PROJECT  
**719 JENIFER ST**

SHEET NAME  
**ROOF PLAN & ELEVATIONS**

**From:** Bradley Servin <b.servin@adcidesign.com>  
**Sent:** Thursday, June 22, 2023 8:14 AM  
**To:** Bailey, Heather  
**Subject:** 18-037 : updated materials? (File Transfer - Ryan Reda - Home Addition - Madison, WI)

**From:** Bailey, Heather <HBailey@cityofmadison.com>  
**Sent:** Wednesday, June 21, 2023 3:42 PM  
**To:** Brad Servin <b.servin@adcidesign.com>; Ryan Reda <redasbac@gmail.com>  
**Cc:** Mark Hazelbaker, Esq. <MH@kasieta.com>  
**Subject:** RE: updated materials?

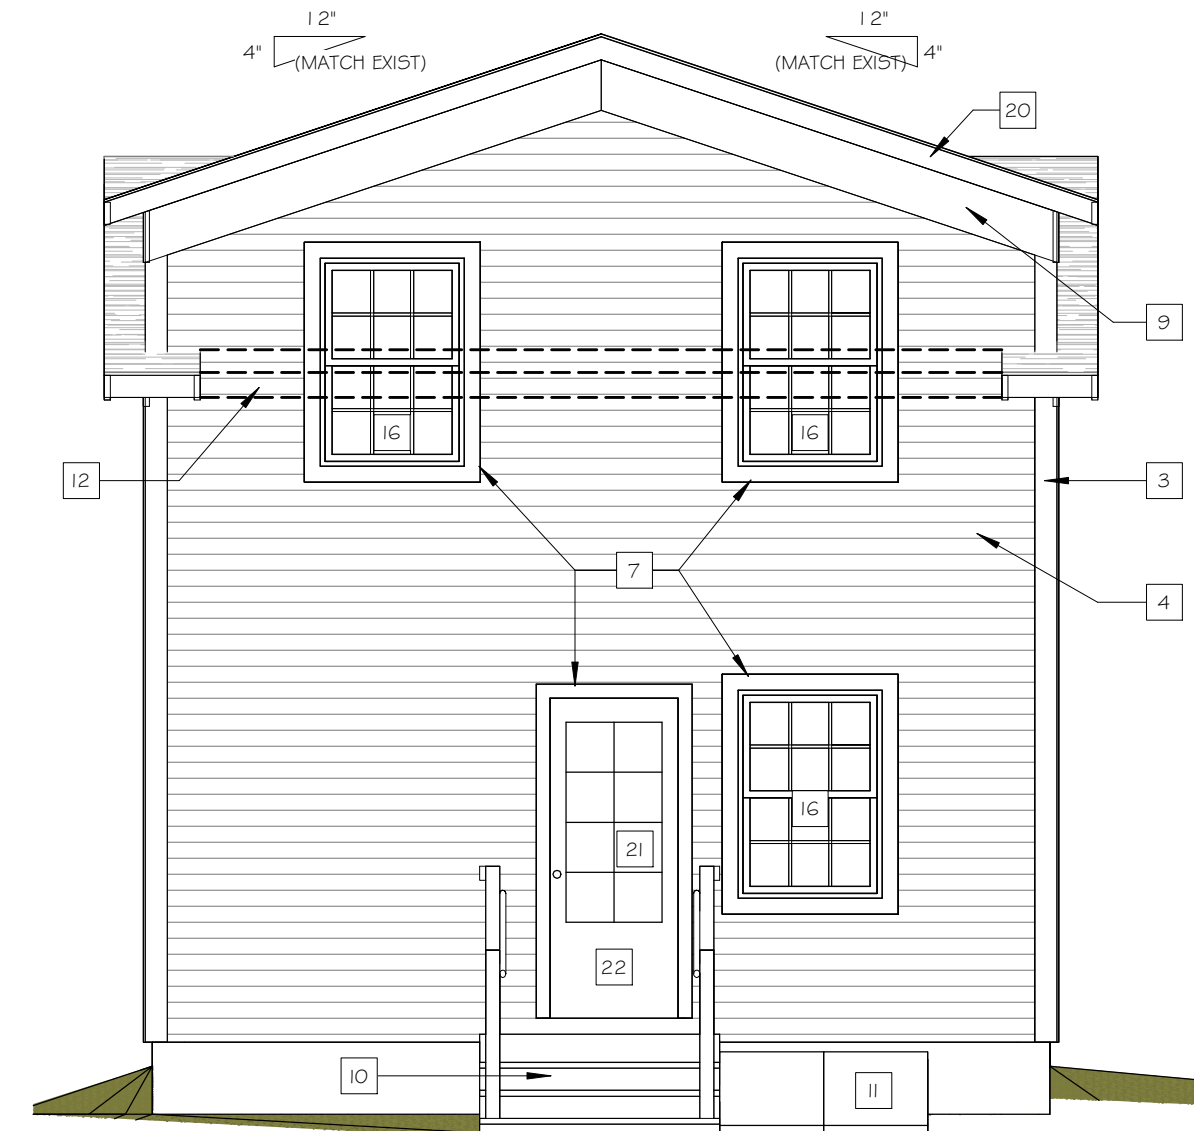
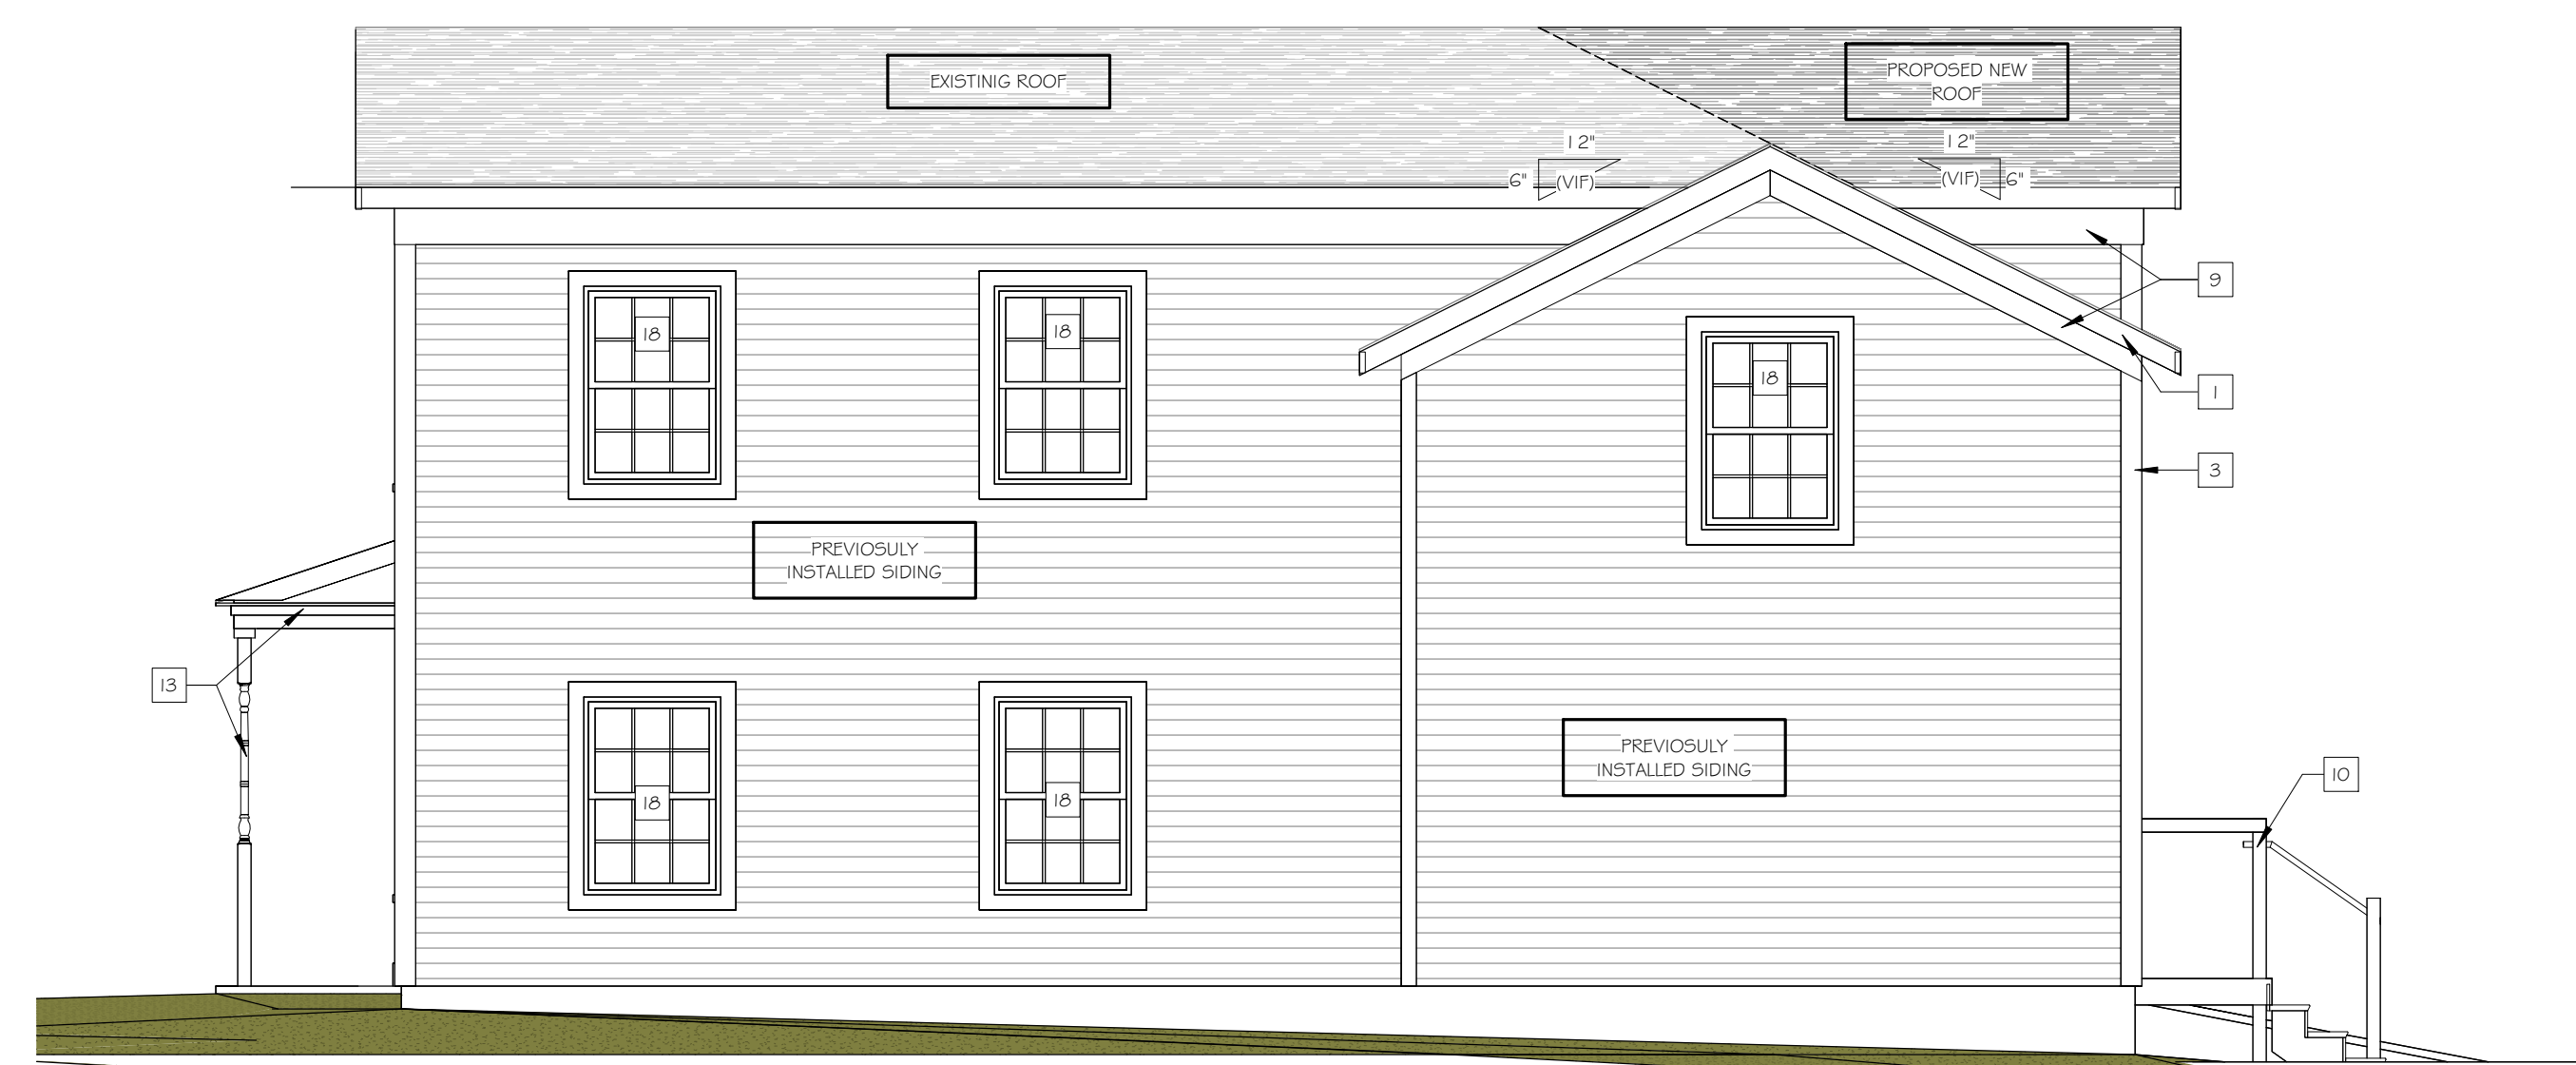
Note 10. We will need specs on the type of material proposed for the rear porch railing. **Rear porch railing basis of design is Azek Timber Tech Classic Composite Series: Color White – Cut sheet is attached**

Note 11. How are you completing the work for the rear basement access stair? Will this just be a new BILCO door? Or will this entail something else? **Attached are additional Photos of the basement access door. The door itself is in good condition and does not require replacement. The intent is the flash the door to the exterior building wall to create a water tight seal and repair the concrete slab around the door to create positive drainage way from the structure.**

Note 13. At our last meeting, I had asked for specific details on what all would happen with the front porch replacement and Ryan assured the commission that this only required some very limited replacement. If we're replacing the porch, we need specifics on what materials will be used and how that work will be undertaken. If there are only a few places that need splicing in material, that's another matter. **Attached are two closeup photos of the existing entry porch. As you will see the parts and pieces of the porch roof construction and supports or not off the shelf products. There are no specs to provide. The intent is to replace deteriorate members with in kind crafted pieces as required.**

Note 16. Your note says that the window will have a vinyl exterior. The previously supplied specs for the windows had an interior vinyl frame, but a metal clad exterior. Will this be the same type of window as previously installed or is this to have vinyl exterior? **I did visit the site this morning and confirmed the window exterior cladding is metal. I was of the impression that the exterior cladding was vinyl. All proposed windows are to be aluminum clad to match what was initially installed.**

Note 17. I think that the note for this item is incorrect as it talks about windows, but it denotes an area of fascia. **You are correct. The notes have been removed. New plan sheet attached.**

Note 18. Likewise, this material says that it is fascia, but it is clearly a previously replaced window. **You are correct. The notes have been removed. New plan sheet attached.**

Note 21. We'll need final specs on these. A new rear door and storm were proposed with the 2021 approval and I don't know if you're proposing that again or if you're looking at a different product. **The back entry door and screen have been separated with individual tags on the updated plans. With specific notes regarding product selection. Let me know if you need anything more.**
